Responses to s92 requests prepared by EGL in
respect of waste rock stack geotechnical matters

Oceana Gold (New Zealand) Limited
Macraes Operation

23 August 2024

**OCEANA GOLD (NEW ZEALAND) LIMITED
MACRAES OPERATION
MACRAES PHASE 4
WASTE ROCK STACKS - SECTION 92 RFI REPLY**

Figure A03

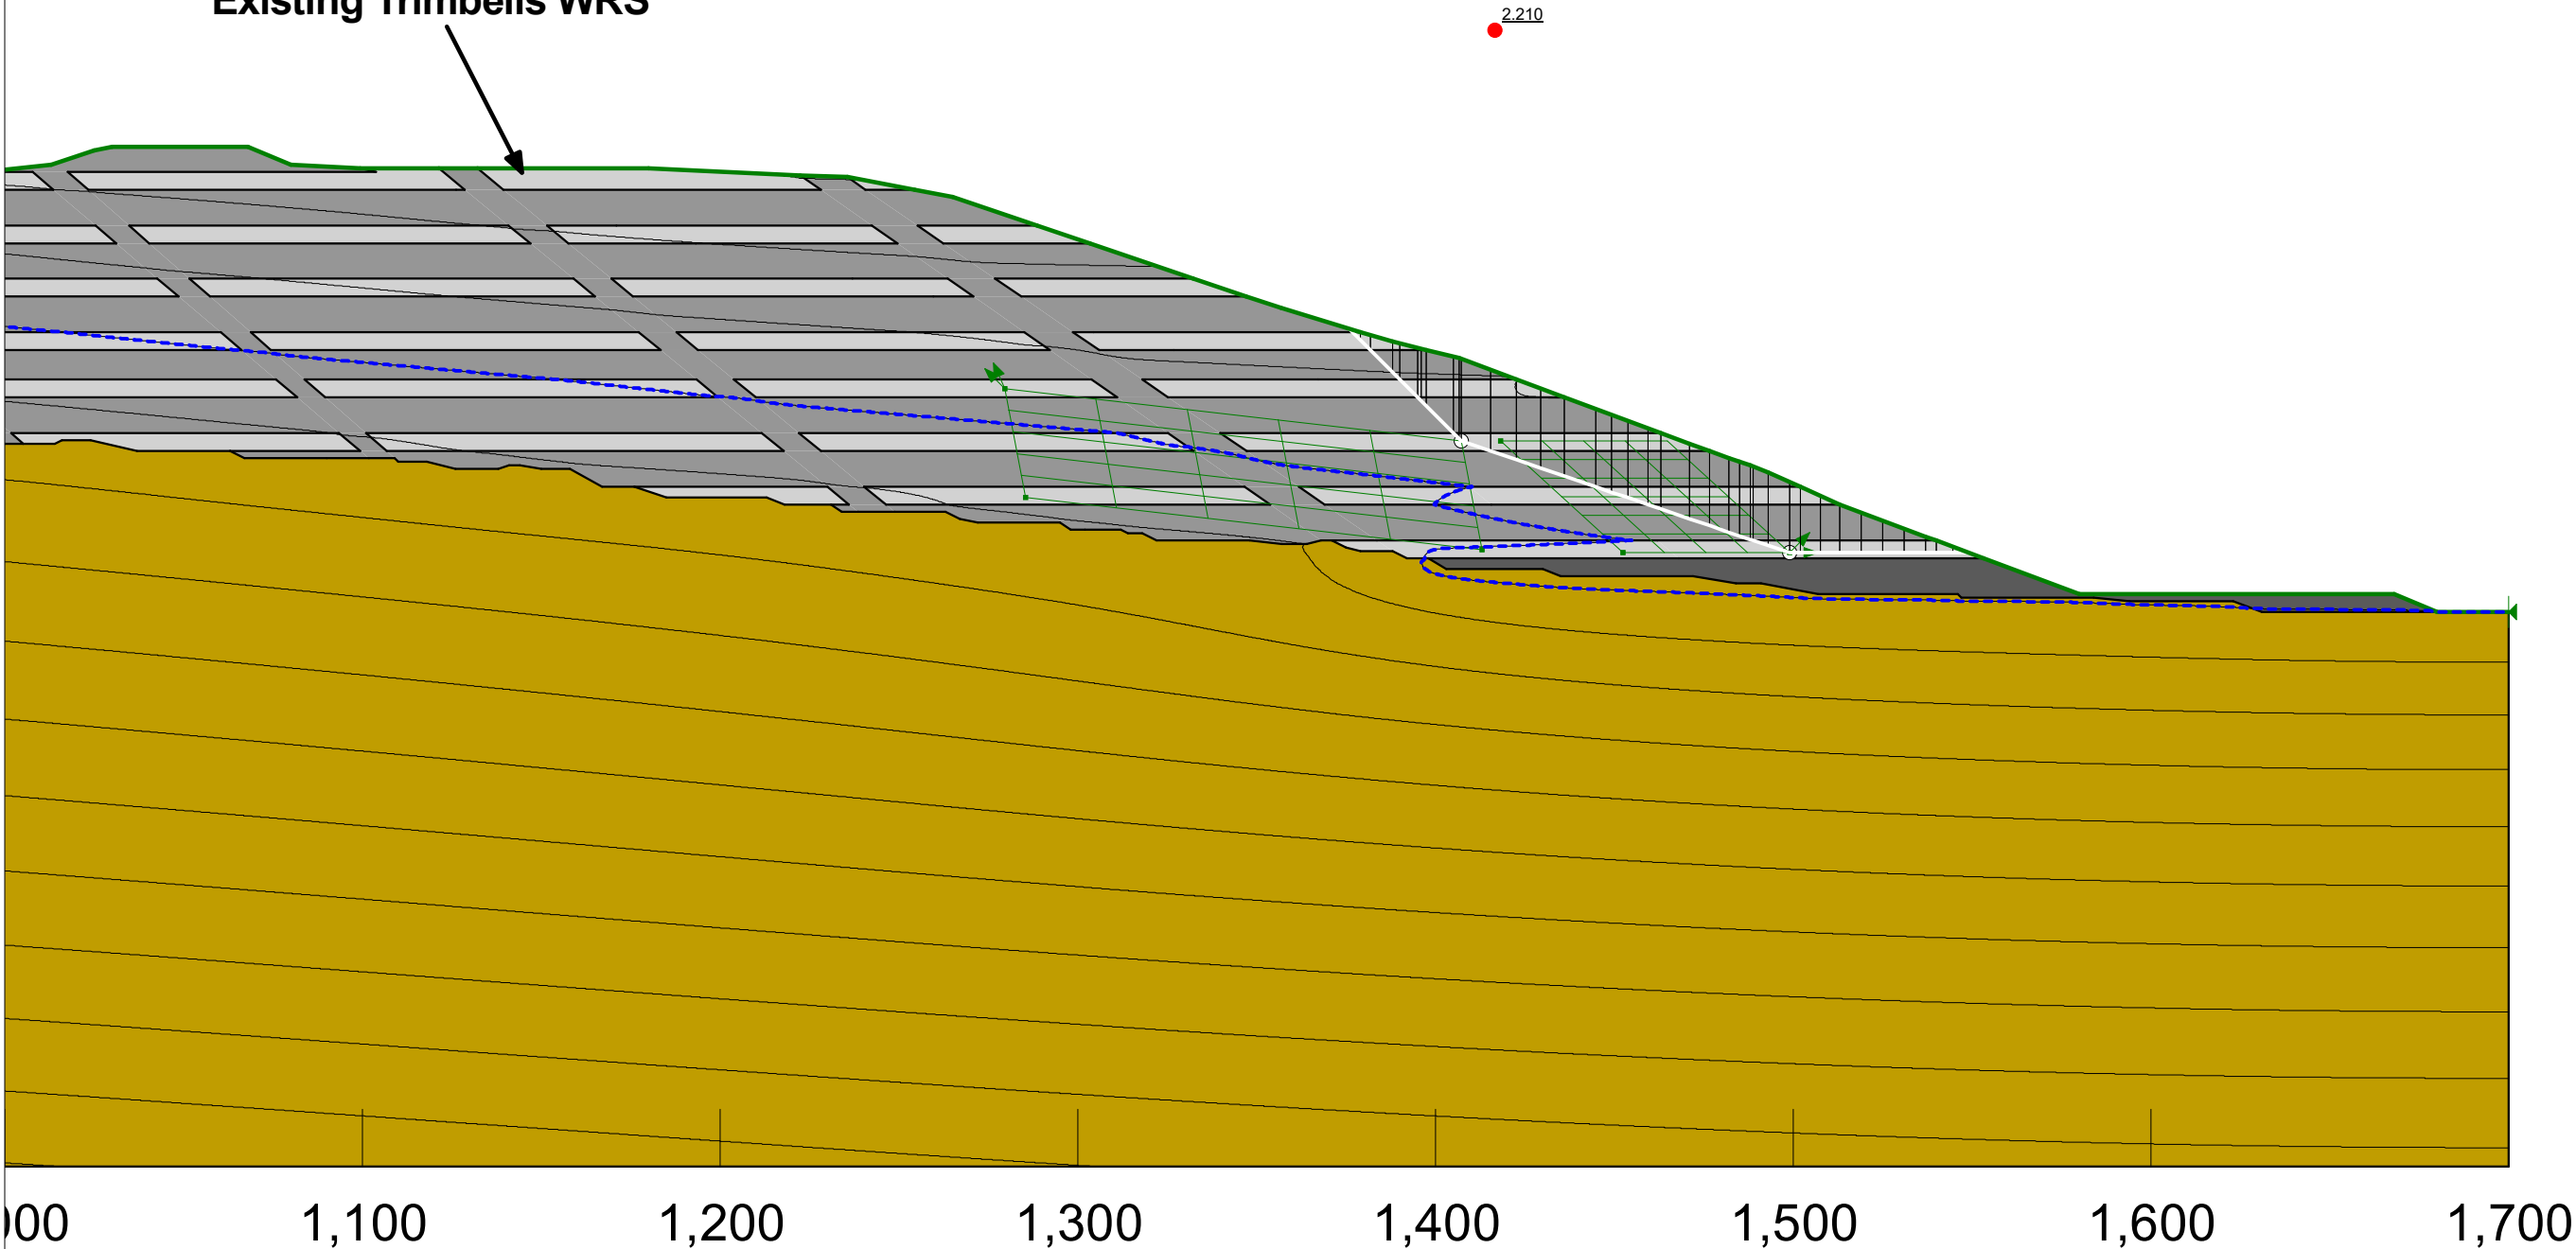
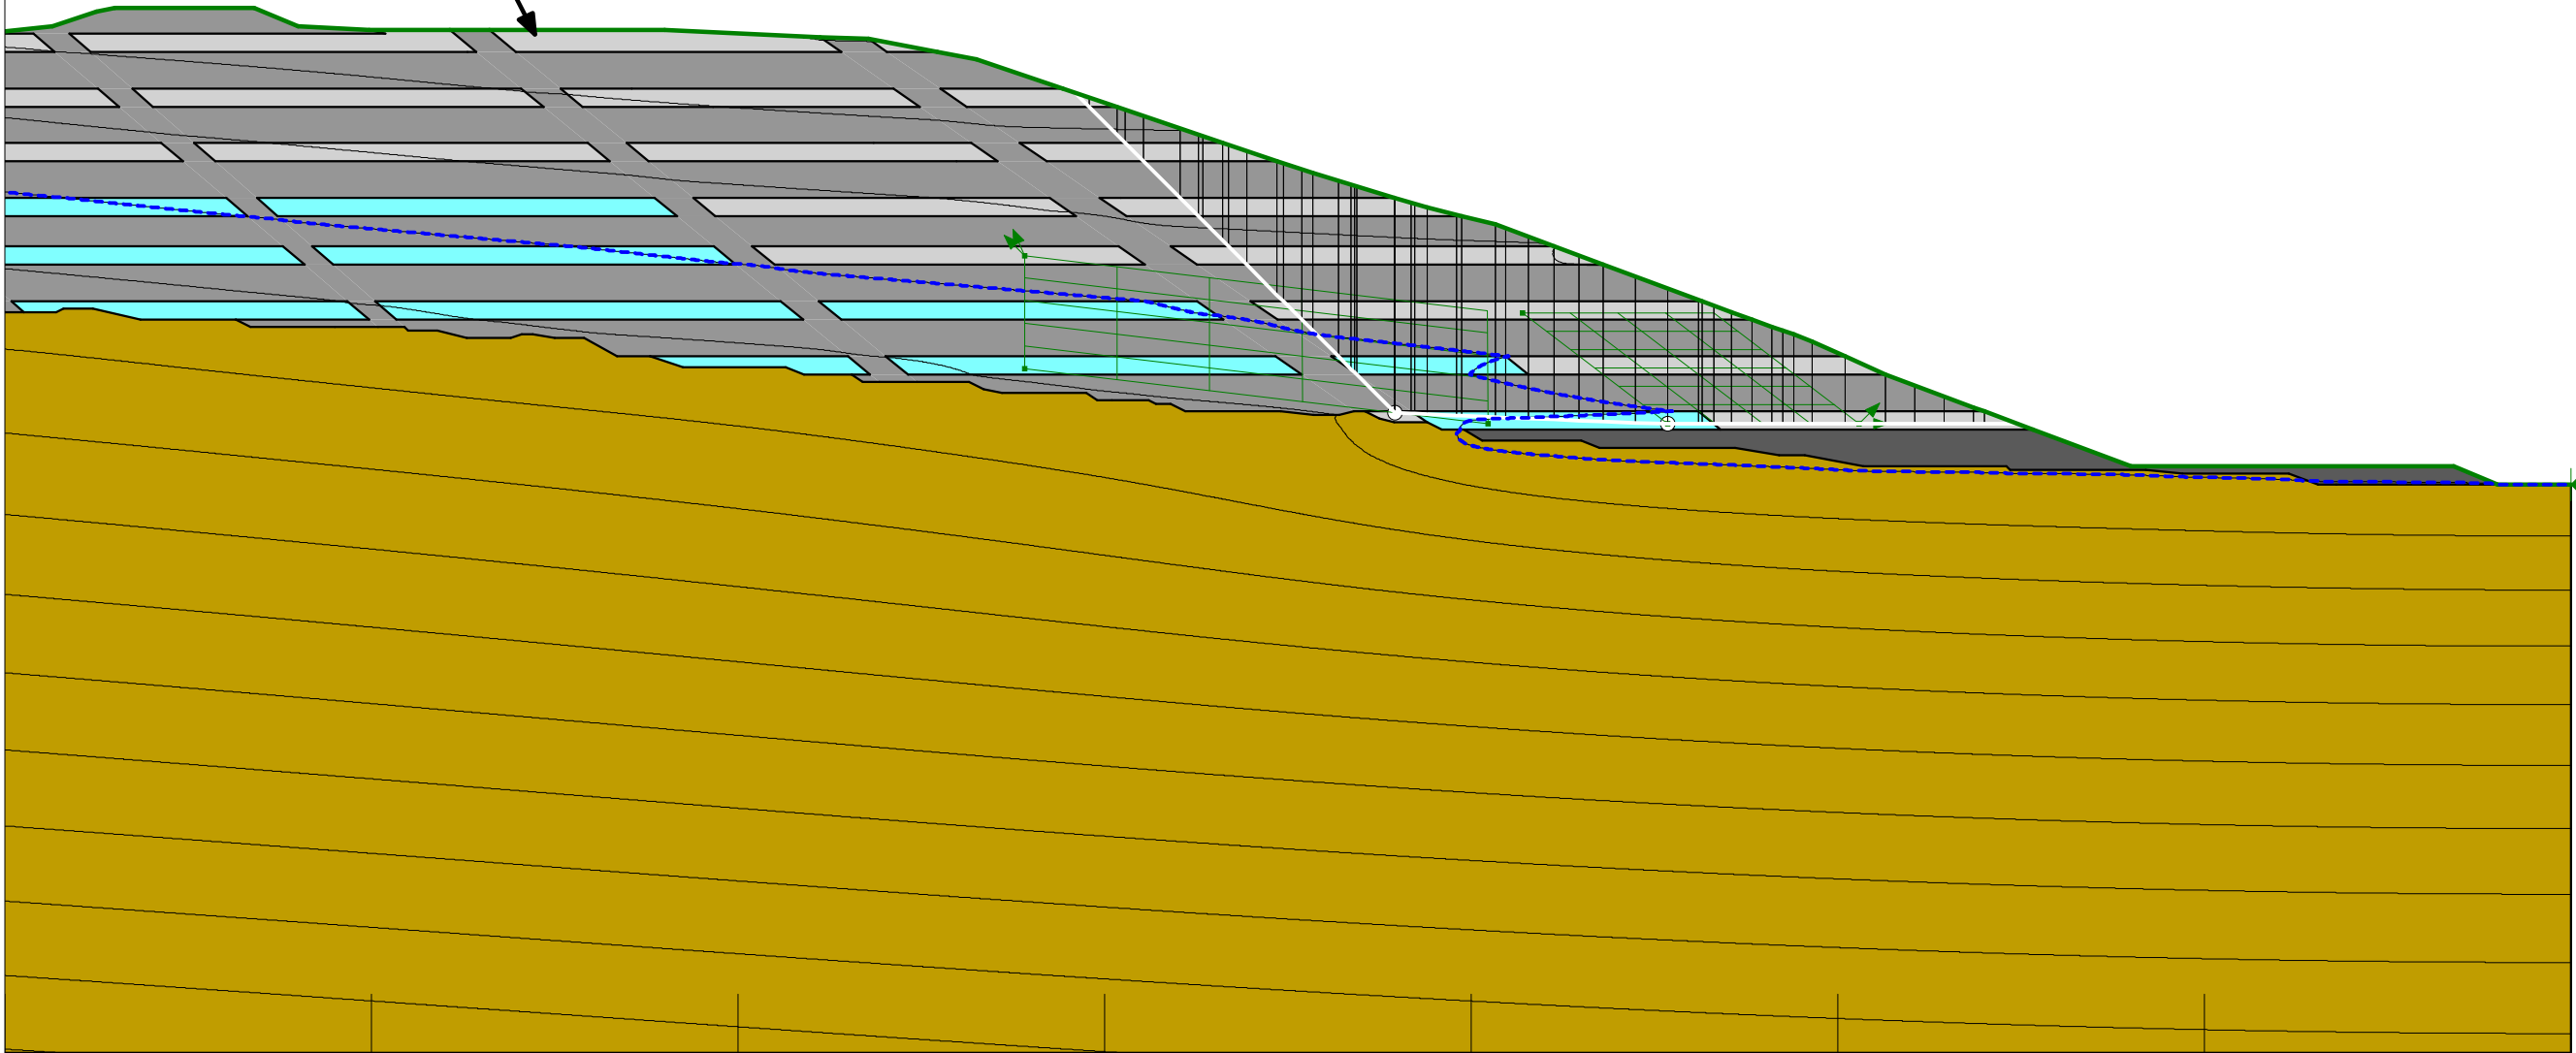
- 2.5 *The stratified model (EGL 2024b) only considers circular failures. **Is a non-circular failure running along the weak layer not more critical? Please explain.***

Yes, the planar failure is critical. The Trimbells Waste Rock Stack – Closure Stability Report has been updated to include planar failure as a more critical mechanism along the weak layers. This update includes a combined review and update of the:

- Planar slide mechanism
- Seepage condition in the waste rock stack for a layered profile
- Stress condition in the waste rock stack for the layered profile

The updated assessment demonstrates that the waste rock stack performance is acceptable in closure. The update has included a more realistic pore pressure profile. This is documented in the updated Trimbells Waste Rock Stack – Closure Stability Report (Rev. 1 of the report, see Section 1).

Figure A04

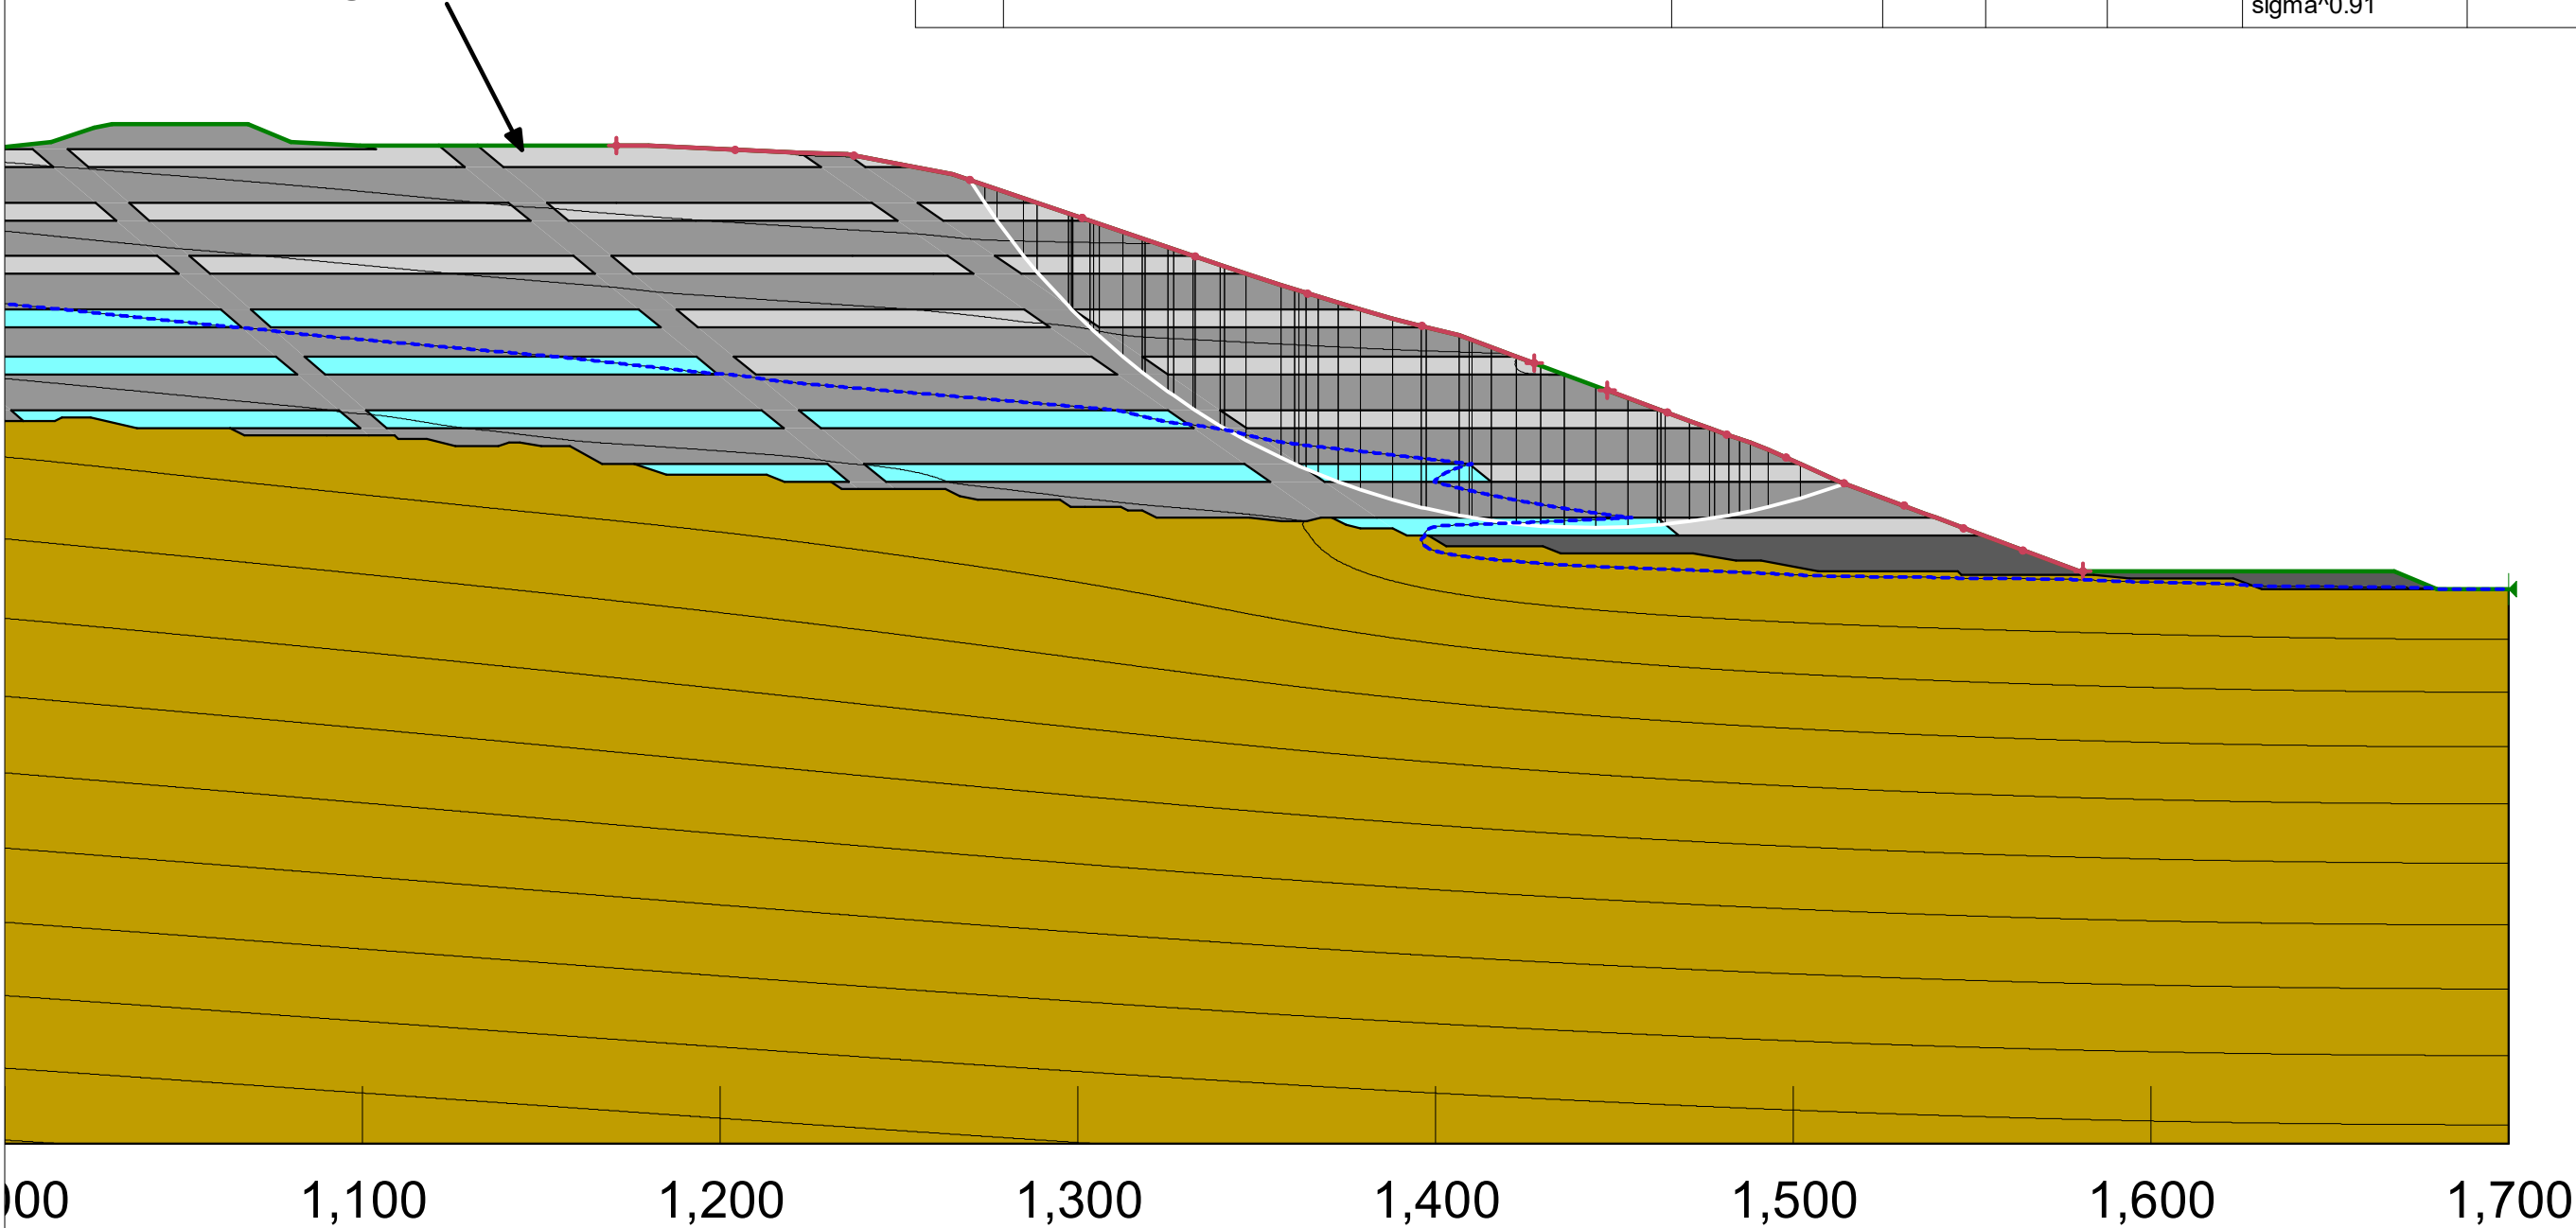
- 2.4 *The EGL (2024b) report mentions that the stratification results in contrasting strength within the WRS. The analysis only seems to use a stratified model on Figure A04, which is labelled as a post-earthquake scenario. Why is this stratified model not used for standard static and EQ analyses? Given the free draining rockfill, strength loss post-earthquake does not seem likely. Please explain.*

Pore pressure increase is unlikely to be notable under the static shear case or 150 year return period earthquake shaking case. The static strength parameter for waste rock when not softened (i.e. static and earthquake 150yr RP) already also allows for the finer fraction stratification. For the 2500 year earthquake we intend to run finer fraction softened strength. EGL will update the report to include this case. This will result in an increase in displacements. EGL has updated the Trimbells Waste Rock Stack – Closure Stability Report (Rev. 1 of the report, see Section 1).
